HIROSE ELECTRIC CO., LTD.
5-23, OSAKI 5-CHOME, SHINAGAWA-KU, TOKYO, JAPAN

Notice of Form Change of Lock Guard of DF60 Crimp Socket and Request for Your Acknowledgement

■ DF60(R)-●S-10.16C(##)

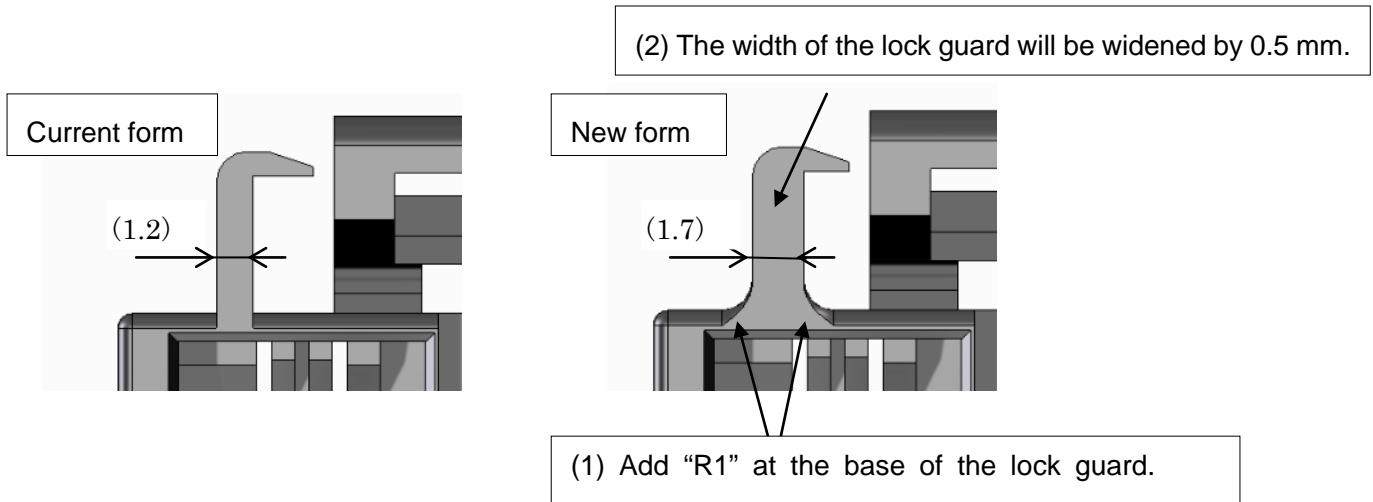
The form of the lock guard will be changed as follows:

- (1) Add "R1" at the base of the lock guard.
- (2) The width of the lock guard will be widened by 0.5 mm.

To enhance the strength of the lock guard.

The strength of the lock guard will be enhanced. There will be no other change in product performance. Also, there will be no change in mating counterpart or compatible crimp terminals.
